# 1965 Corvette: Service Bulletin: Turn Signal Switch - Failure to Cancel

**Subject:** Turn Signal Switch - Failure to Cancel

**Bulletin Number:** DR #706, Section XII

**Date:** October 26, 1964

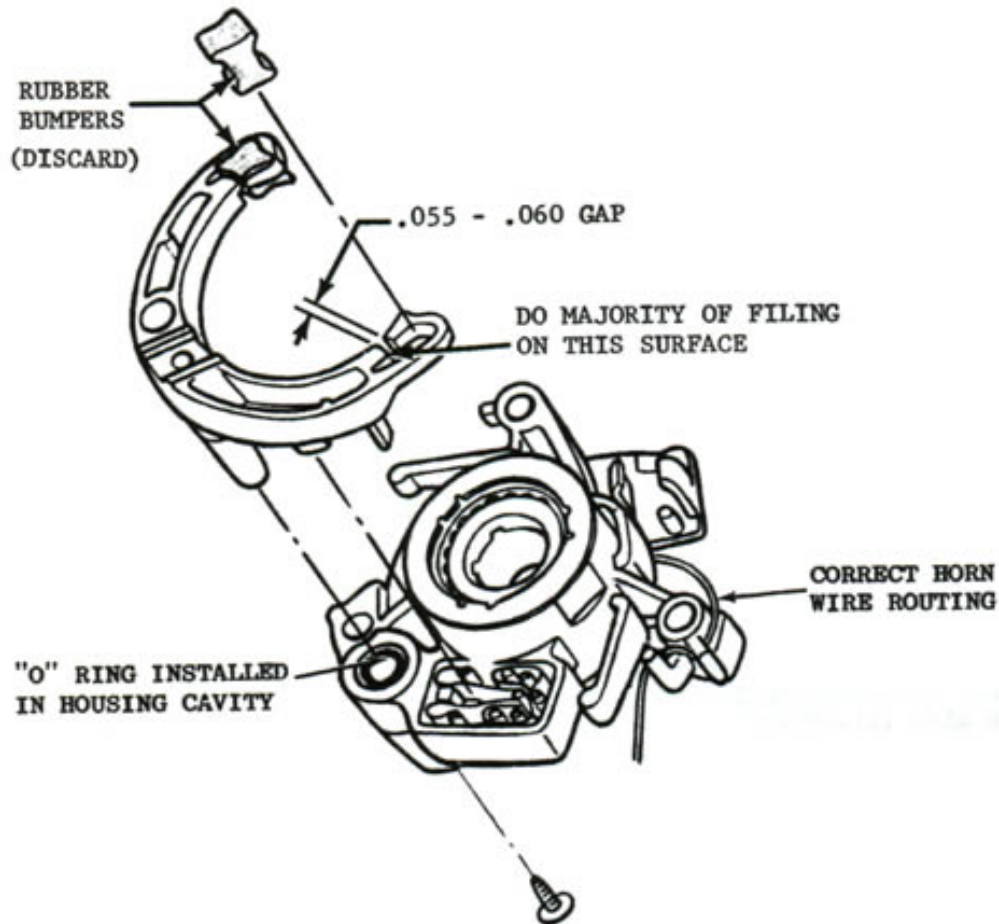
Early production 1965 vehicles, except Chevelle, may exhibit a "failure to cancel" or a "partial cancel" condition of the turn signal switch assembly. This condition is prevalent from the right turn position and caused by a number of variables within the switch assembly. The cancelling cams are not the cause of the malfunction.

A complete failure to cancel is obvious but when partial cancel occurs, the turn signal lights will go out but one brake light will be inoperative. This could easily be incorrectly diagnosed as a bulb, socket, or wiring failure.

It should also be noted that if for any reason the actuator lever is removed from the switch body, the "O" ring must be placed in the body cavity (as shown on the attached sketch) when reinstalling the lever. The correct horn wire routing is also illustrated in the sketch.

2. Remove and discard both rubber bumpers from the actuating plate (see sketch).
3. Using a small file, such as an ignition point file, open the gap in the cancelling pawls to .055/.060 (rework both sides). NOTE: After cleaning any flash from the moveable arm face, perform the stock removal from the stationary arm.
4. Blow out loose filings with air hose.
5. Replace the steering wheel, temporarily, and test the switch for cancelling.
6. If the switch now works correctly, reinstall the steering wheel. If the switch still fails to cancel, it will be necessary to replace the switch assembly (Part No. 910821).
